**DATE:** FEBRUARY 15, 2022  
**SUBJECT:** LETTER OF CLARIFICATION NUMBER 1  
**RE:** RFP NO. 2022-010 RADIO FREQUENCY IDENTIFICATION SYSTEM (RFID):  
CONVERSION AND EQUIPMENT  
**OWNER:** CITY OF EDINBURG  
**TO:** ALL PROSPECTIVE PROPOSERS

**THIS LETTER OF CLARIFICATION IS ISSUED FOR THE FOLLOWING REASON:**

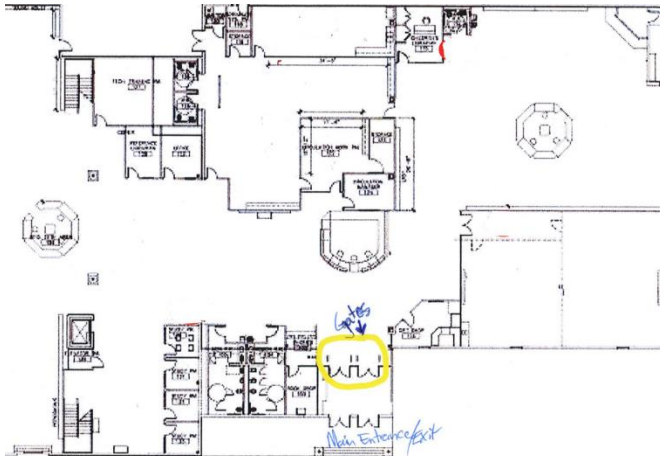
**29.** Can you provide exact Gate specs? Quantities and type. A premium or wide isle gate has a read range of 63' between columns, a standard RFID gate is 39.5" on center between columns. The pricing table is not clear.

**A. Two of a two Colum gate that accommodates double doors. Below is a picture of what we currently have and would need.**
